Technical Service Bulletin: TSB260042

Fuel Pump Improvement

This Technical Service Bulletin informs the field of improvement made to the fuel pump used on QSK23, QSK45, QSK60, QSK78 HPI Engines.

Figure 1, Assembly with fuel pump serial number location

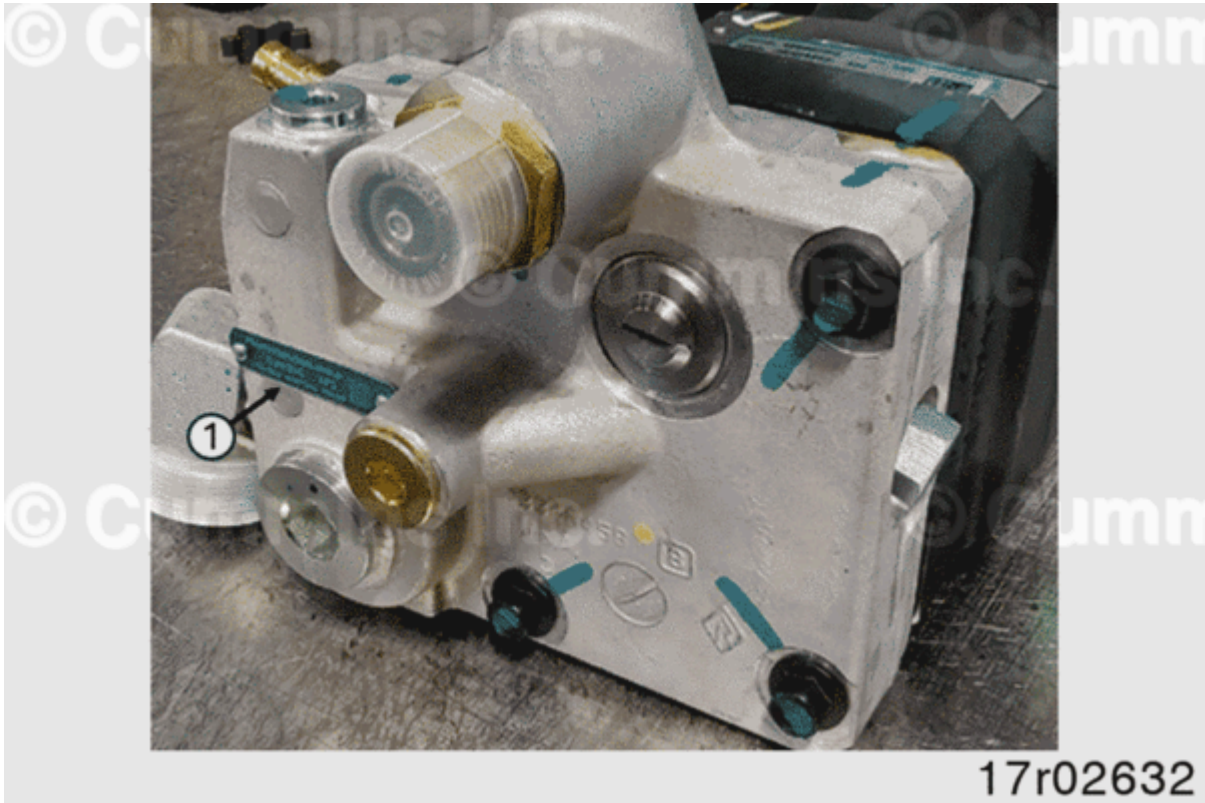
This improvement reduces the potential for damage to the maximum pressure relief valve small o-ring installed in the regulator housings on fuel pumps built after and including fuel pump Serial Number P4097076S512521300004 (built after 01 August 2025 at Cummins Fuel Systems - Columbus).

This improvement is a running change to the current fuel pump(s) regulator housings and part numbers (PN) did **not** change. Improved fuel pumps may be identified by fuel pump Serial Number as described but no specific inventory actions required at this time. See Figure 1.
